City of Rancho Palos Verdes
 Rancho Palos Verdes ADA Assessment
 Facility Report with Photos

Facility ID: # Area 5 Bus Stops

Location: Hawthorne Blvd./ Crest Rd. (SB)
Photo # 53

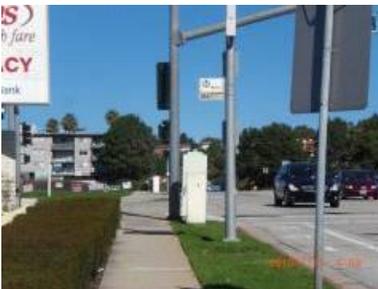
Keynote 54
